STATE HISTORIC PRESERVATION OFFICE (SHPO) QUESTIONS & RESPONSES

Fort Apache Home of Harmony Project

March 13, 2024

This Addendum includes Architect's responses to SHPO questions pursuant to Historic Tax Credit (HTC) grant award. These questions have minor effect on the drawings and were not included in during the bidding process to avoid conflict and/or confusion with addendums that directly related to bidding/pricing. Some of these questions necessitated specific drawing revisions, which were issued with the following narrative responses. These questions and answers, along with revised sheets, are being memorialized as ADDENDUM #9, and affected sheets / Specification Pages are included in the Construction Document Issuance hereafter. While it is not anticipated that these changes have cost implications, the Contractor shall alert the Architect and Owner in the event they do.

DRAWN	STAFF
CHECKED	KG
DATE	03.13.2024
SCALE	3/16" = 1'-0"
JOB NO.	2101
SHEET	A7.01

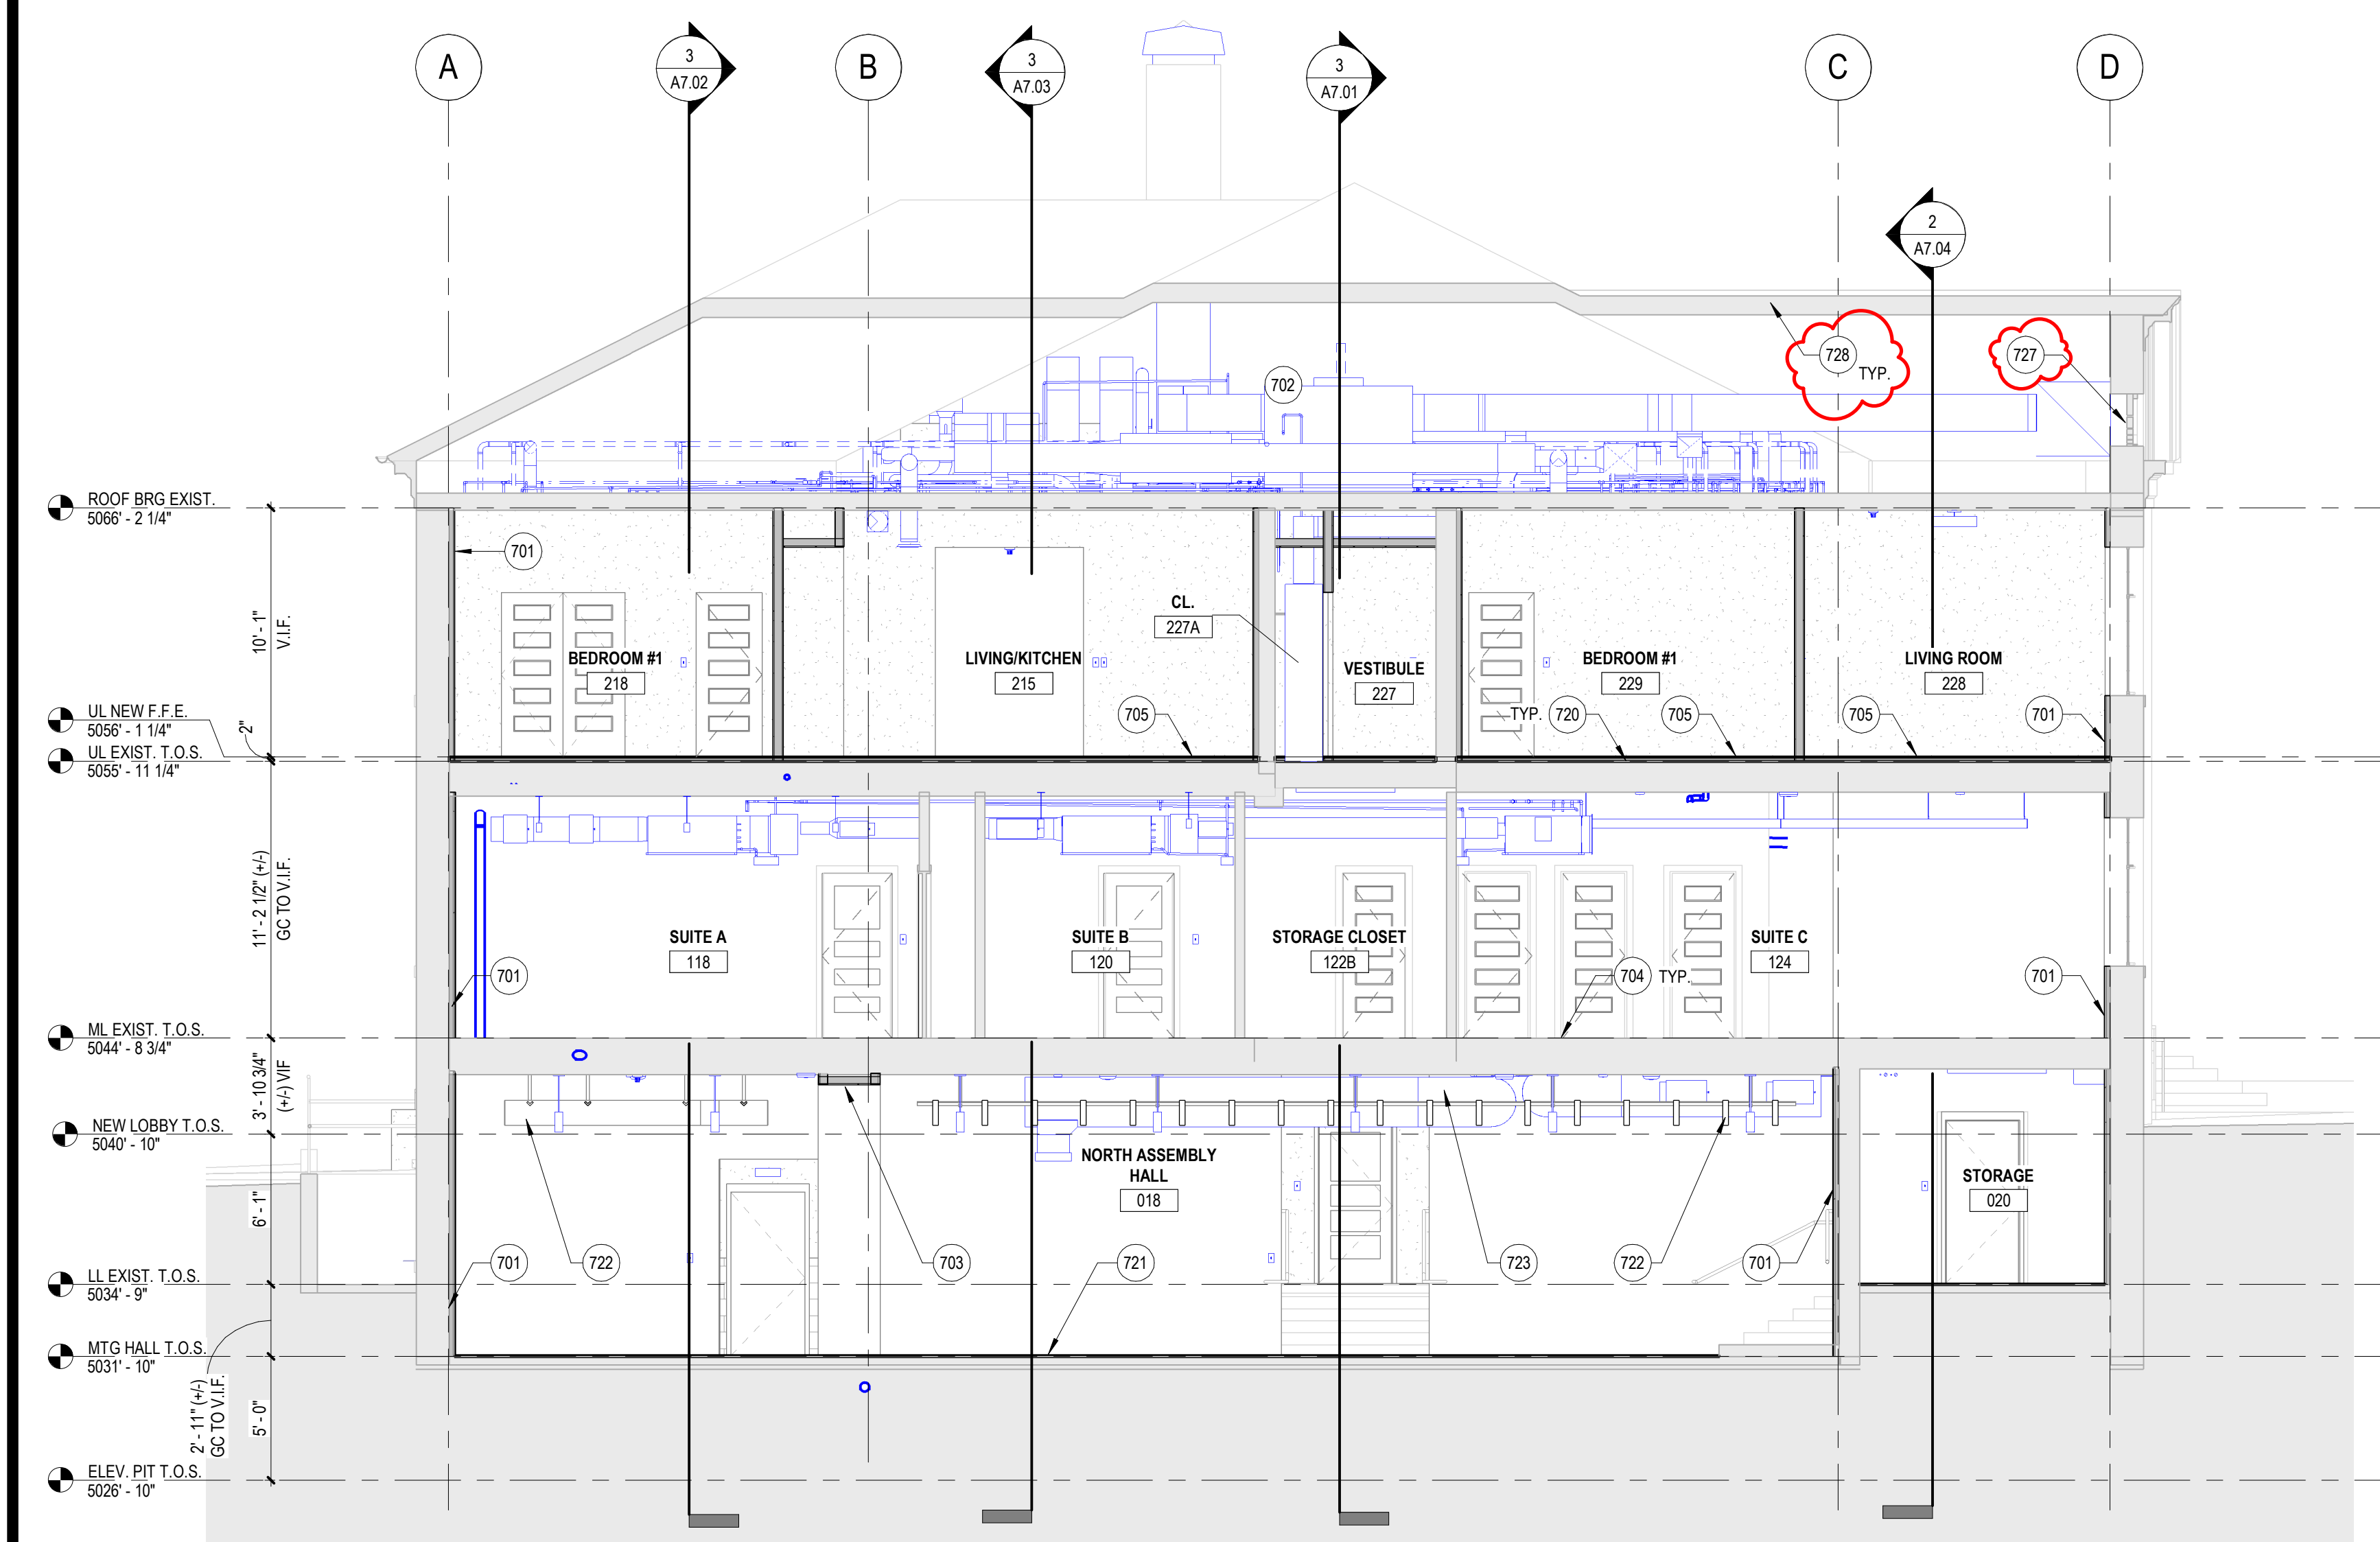
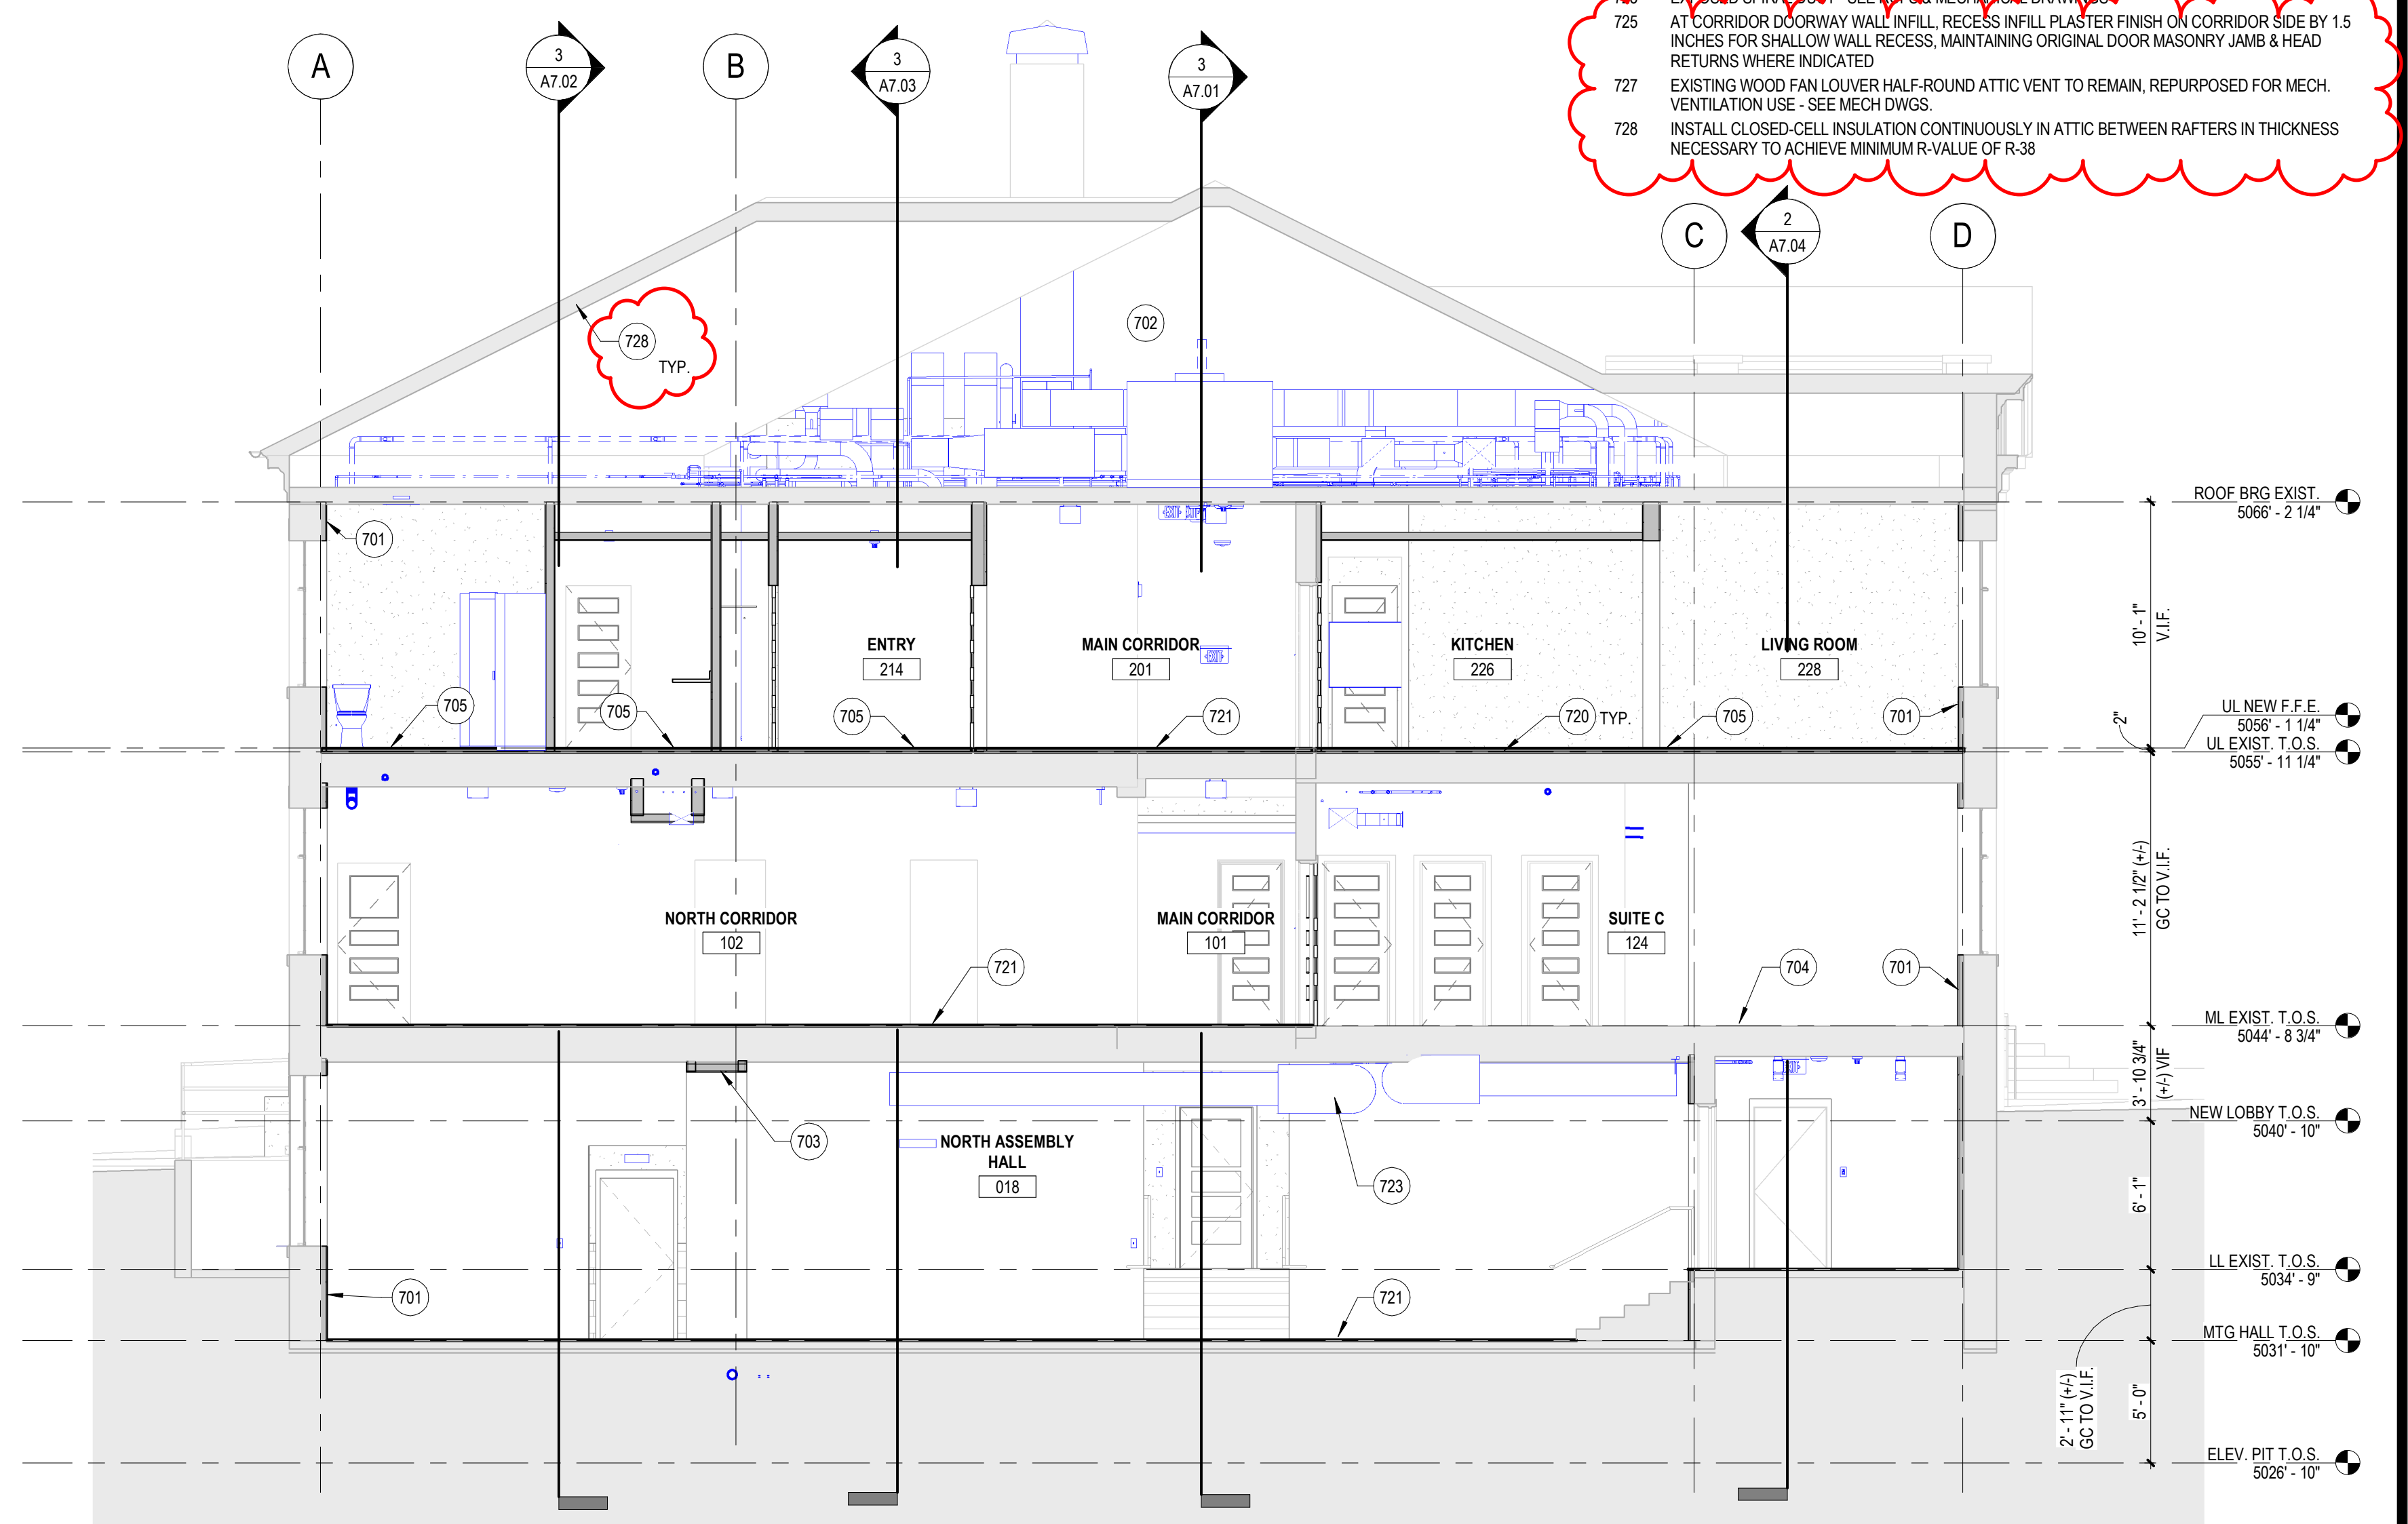
On Sheet A7.01, is attic equipment in front of window?

The two existing half-round louvered opening in the gable ends to be retained and utilized for mechanical ventilation. Additional keynote added to this building section.
